MANDATORY SERVICE BULLETIN**NUMBER:** SB14-05**REVISION:** 00**DATE:** June 12, 2014**SUBJECT:** FLAP ACTUATOR DRIVE CABLE NUT TORQUE**EFFECTIVITY:**

KODIAK® 100 Series Aircraft Serial Numbers: 100-0001 thru 100-0085

TITLE: Flap Actuator Drive Cable Nut Torque
SERIAL RANGE: 100-001 thru 100-0085
JASC CODE: 2750

Figure 5-1: Flap Gearbox Controller, Drive Cable, and Drive Cable Nut

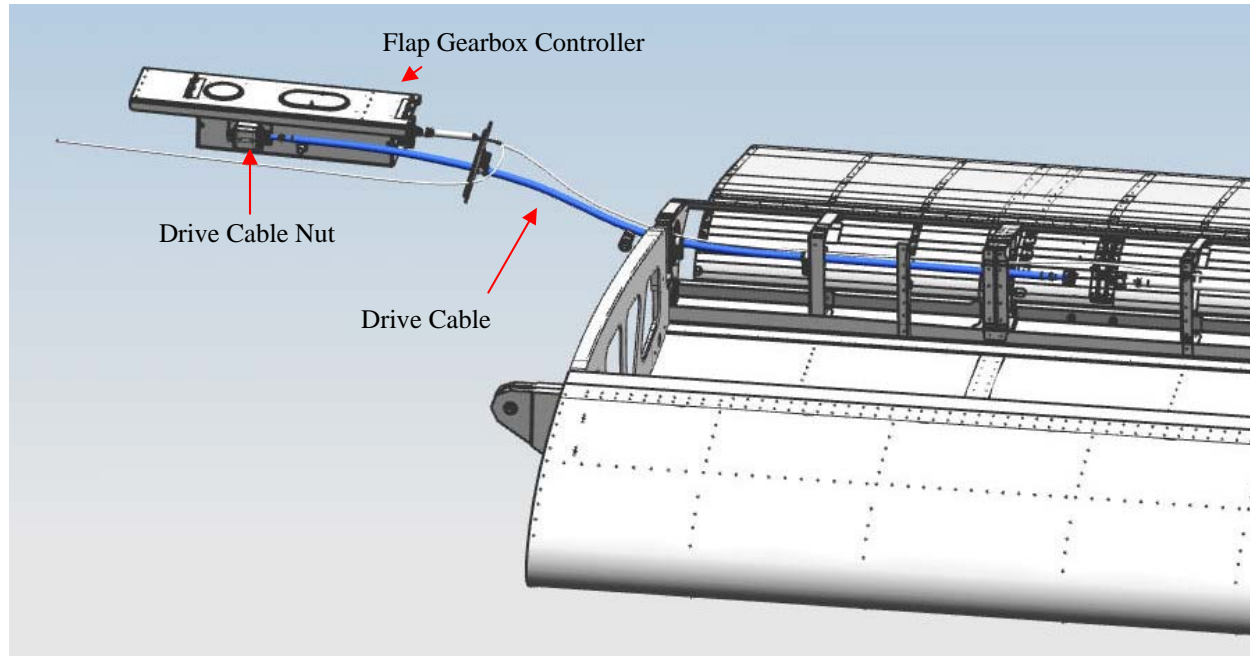
1. Remove the safety wire at the flap actuator drive cable nut.
2. Disconnect the flap actuator drive cable nut at the flap gearbox controller (**Figure 5-1**).

- If damage is found:
 1. Contact Quest Customer Service for product replacement information.
 2. Proceed to Section 5.2.
- If no damage is found:
 1. Reconnect the drive cable nut and torque to 47 – 53 in-lb.
 2. Re-install the safety wire.
 3. Proceed to Section 5.3.

Figure 5-2: Yielded or Bulging Drive Cable Nut

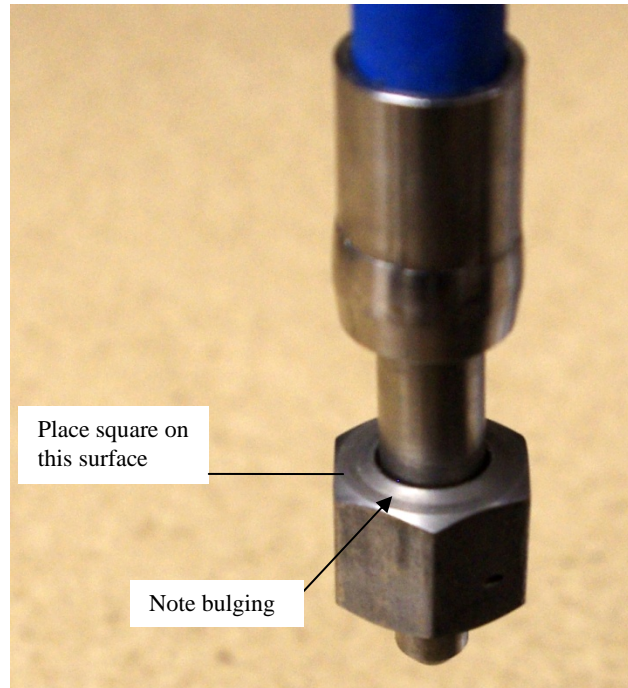
3. Inspect the drive cable nut, noting any cracks, bulges, or yielding (**Figure 5-2**).
4. Verify that the back of the nut is flat by placing a small square across the back of the nut (**Figure 5-2**).
5. Repeat steps 1 through 4 on the opposite side of the aircraft.

Figure 5-3: Disconnection Points for Drive Cable Nuts

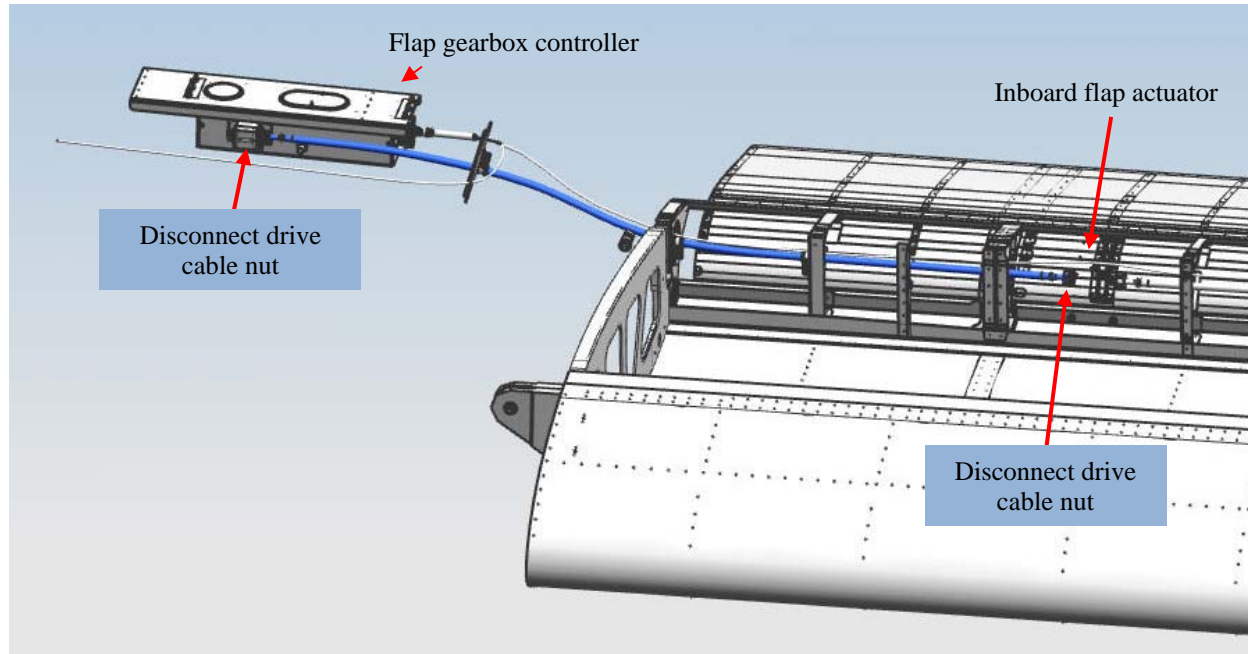
1. Remove the headliner in accordance with the *KODIAK 100 Airplane Maintenance Manual*, Chapter 25.
2. Remove the safety wire at the inboard flap actuator (**Figure 5-3**).
3. Disconnect the flap actuator drive cable nut at the at the inboard flap actuator (**Figure 5-3**).

7. Torque the cable nut at the gearbox controller to 47 – 53 in-lb, and the cable nut at the inboard flap actuator to 160 – 170 in-lb.

The drive cable nuts at each end of the cable are different sizes and require different torque values.
